Subject: **NRC Request for Additional Information – January 8, 2013**

Response to NRC Request for Additional Information dated January 8, 2013

CE Windsor Site
Windsor, Connecticut

Figure 1 – Scan Survey CE-FSS-23-06, Four Data Points

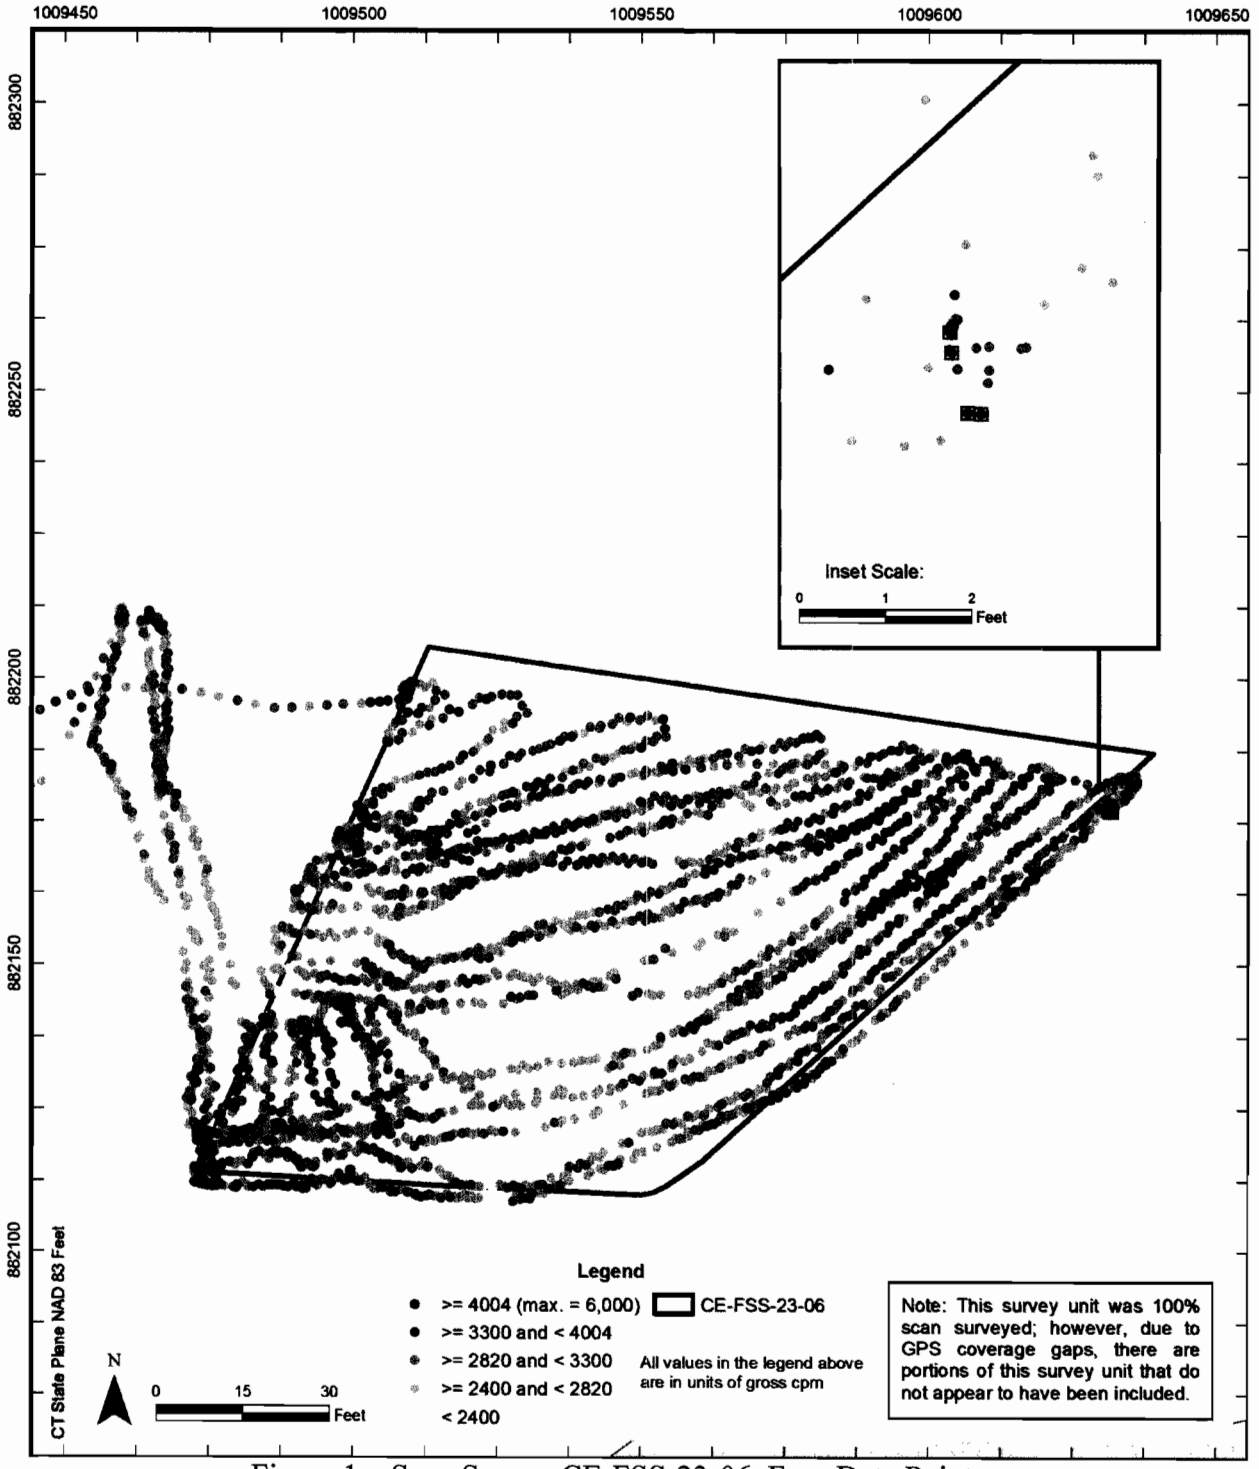
Request for Additional Information Question 2:
Also in FSSR #6, in Appendix E, on page 28 of 52, four results for CE-FSS-23-06 were above the 4,004 cpm scanning investigation level. The results ranged from 6,240 to 31,200 cpm. Please describe how these results were addressed.

Response:
The area of these elevated results was rescanned as discussed in FSSR #6, Section 3.2.5. There were issues with the detector cable connection which was causing false positive results. Figure 1 indicates the location of these four results. The rescan of this area is provided as the next 12 sequential data points following the four results identified in Appendix E. These results are below the 4,004 cpm scanning investigation level. Therefore no additional actions were necessary.
